Letters

Correction to "On the Noise Parameters of Isolator and Receiver with Isolator at the Input"

Correction to "A New Recurrence Method for Determining the Green's Function of Planar Structures with Arbitrary Anisotropic Layers"

Corrections to "Propagation of Quasi-Static Modes in Anisotropic Transmission Lines: Application to MIC Lines"

Fig. 5. Variation of the normalized phase velocities in the broadside edge-coupled microstrips with an inverted substrate of boron nitride, as functions of the tilting angle ($\epsilon_\xi^* = 5.12$, $\epsilon_\eta^* = 3.4$).

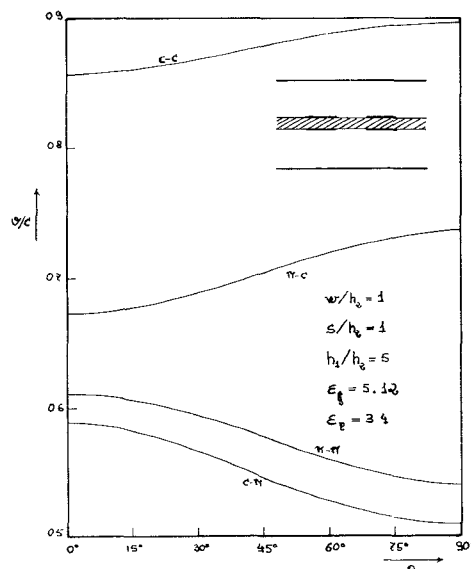
On p. 930, left column, $v_{F,n} = 1/\beta_{s,n}$ should read $v_{F,n} = 1/\beta_{1,n}$. Also, Figs. 5 and 6 are incorrect; the corrected figures are shown above.
